## HISTORIC PRESERVATION COMMISSION

SUBJECT: Historic Area Work Permit #904304: Demolition and stabilization

Applicant: First Agape AME Zion Church (Thomas Taltavull, Architect)  
Address: 7700 Seven Locks Road, Bethesda

Revisions  
Drawing Title  
**DEMOLITION FLOOR PLAN**

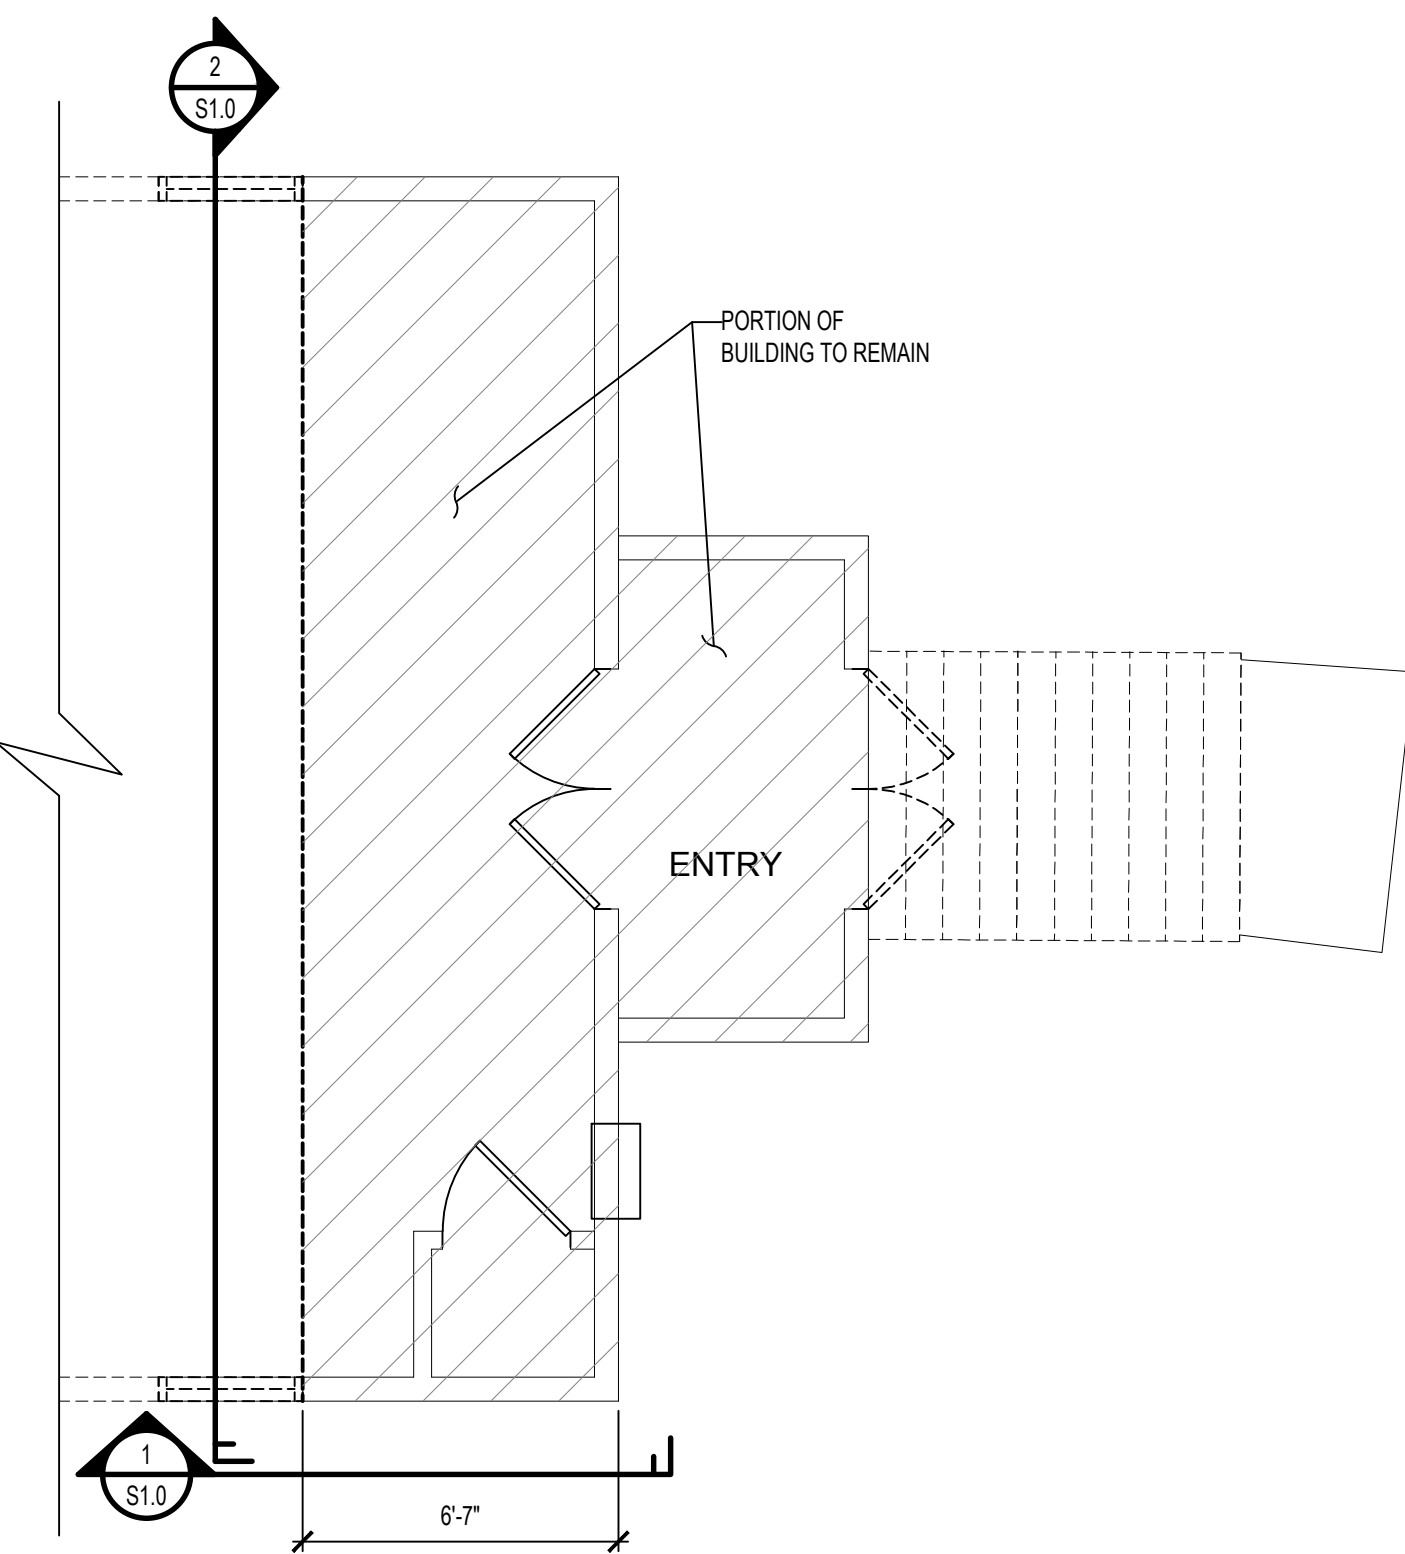
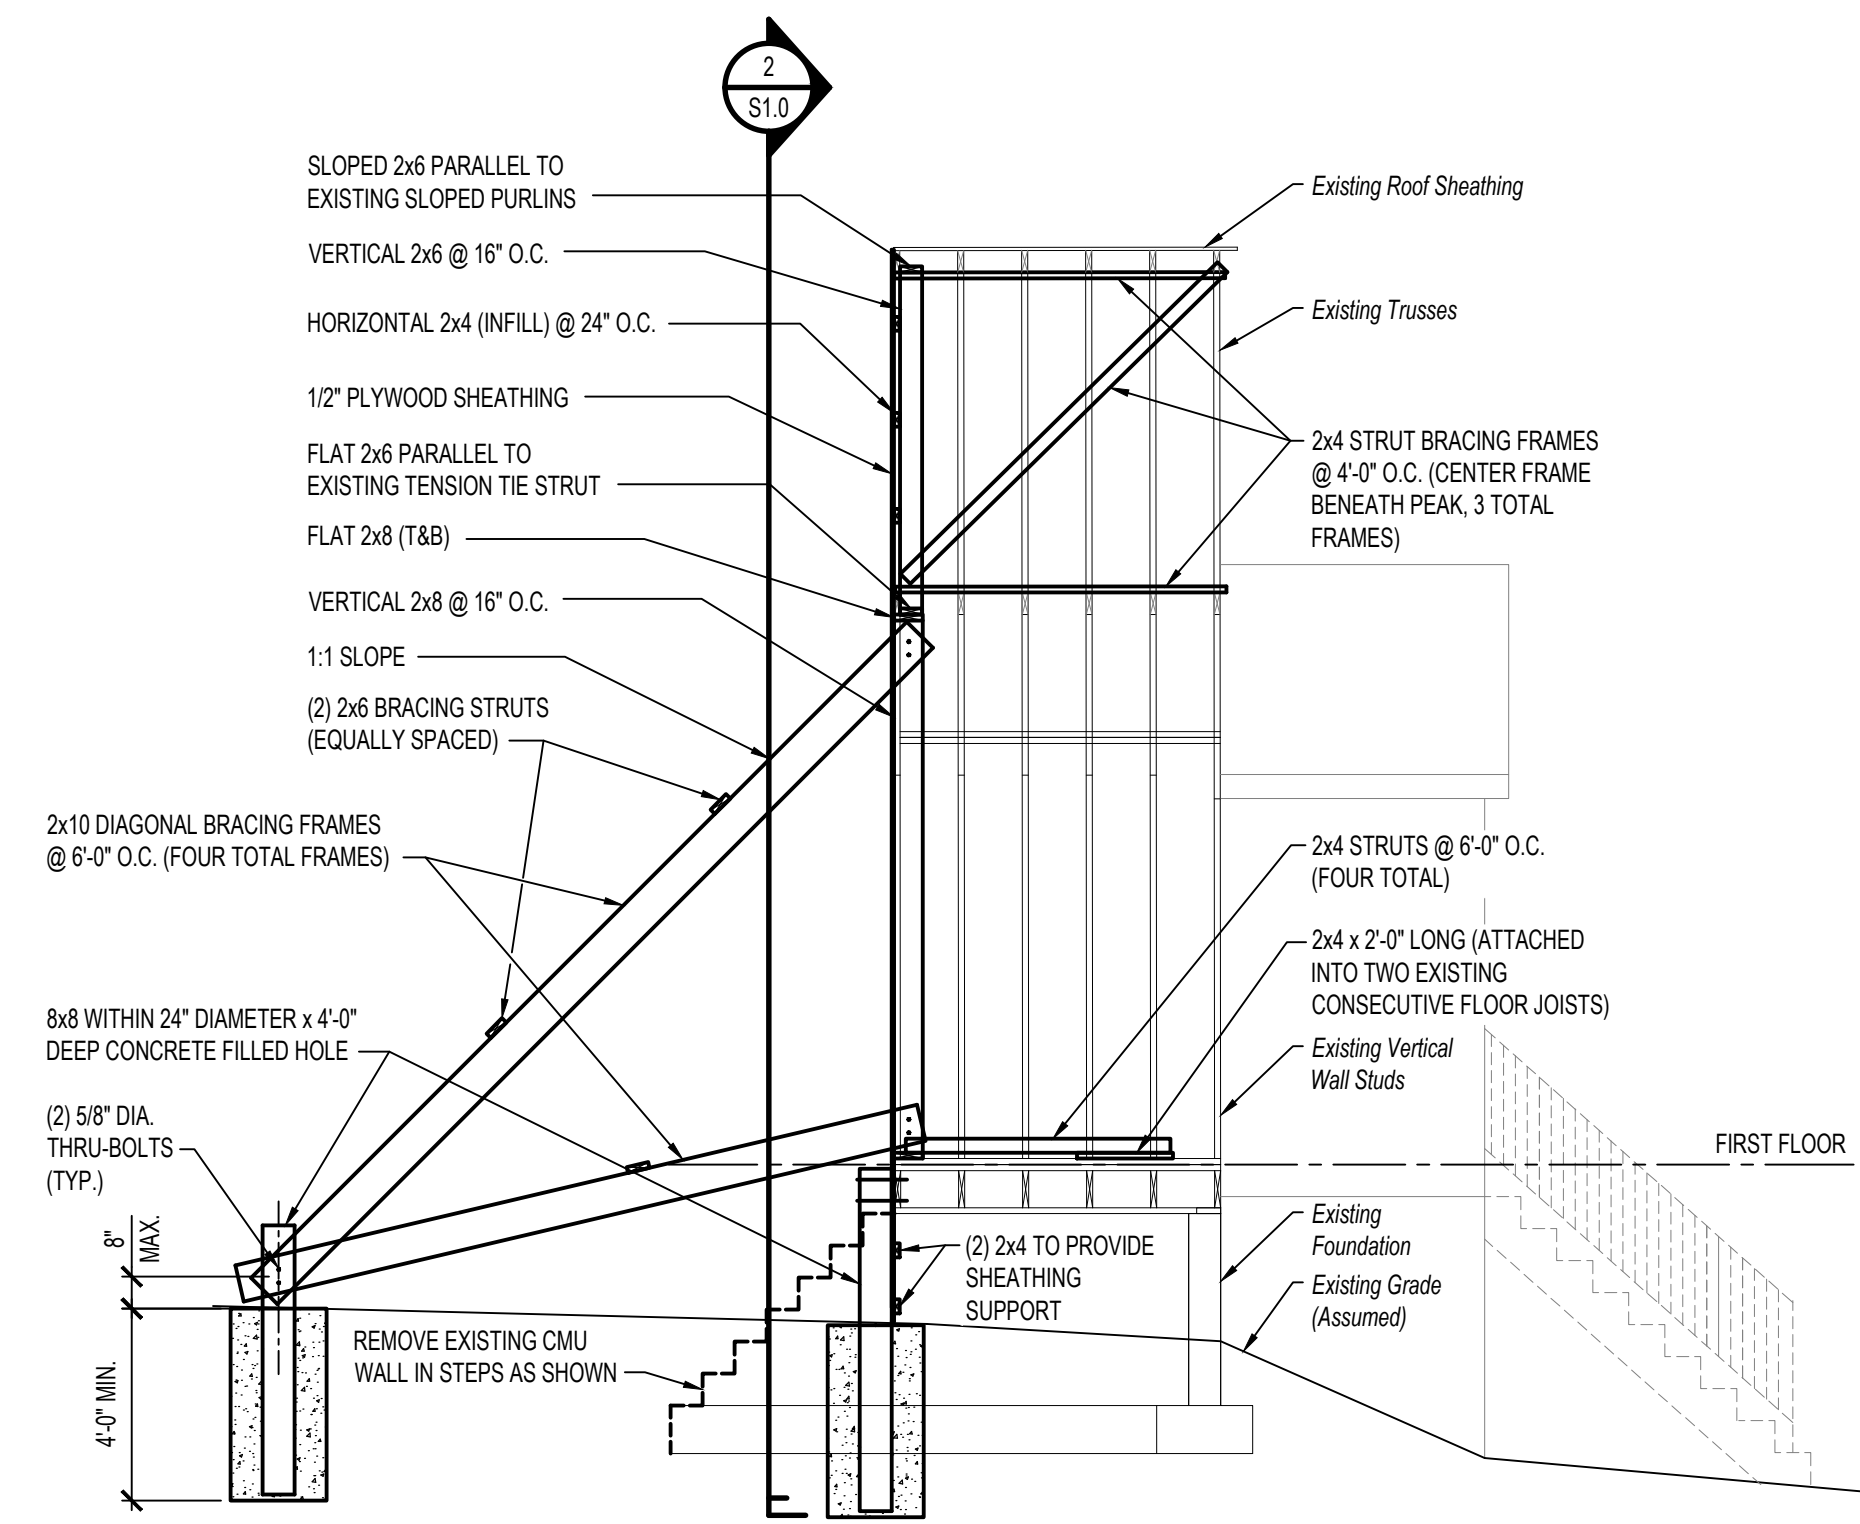
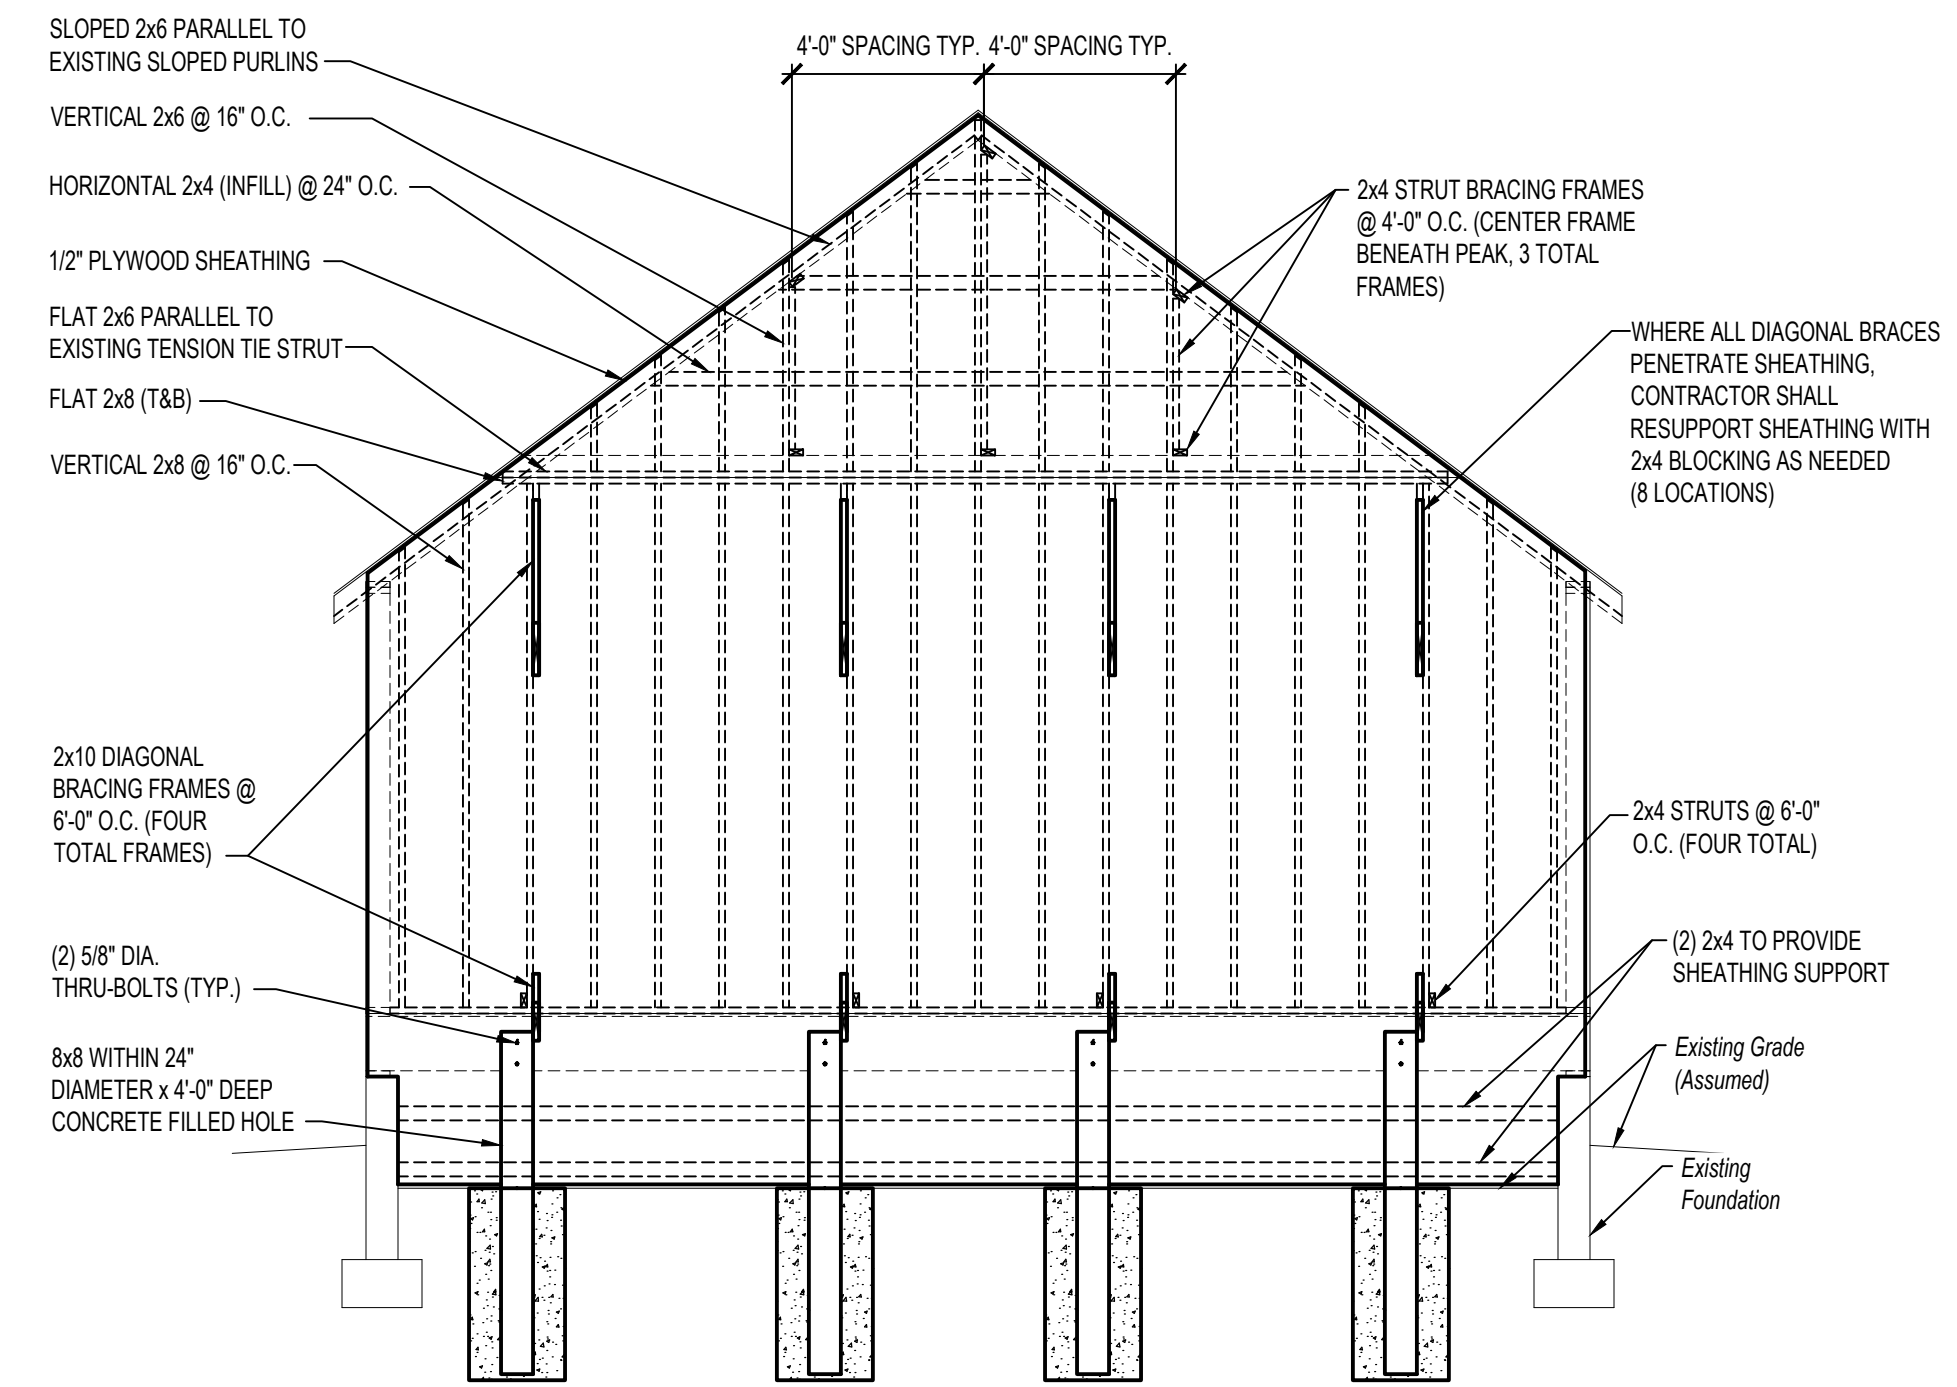
2. The owner has provided a stabilization plan for the front portion of the church that will remain. The plan was prepared by the structural engineering firm Durst and Taylor. The west elevation of the remaining stabilized section is indicated to be sheathed in plywood and will be weatherized with an air and water infiltration barrier building wrap, (Tyvek). The contractor will ensure that the church will be protected from the weather and secured.
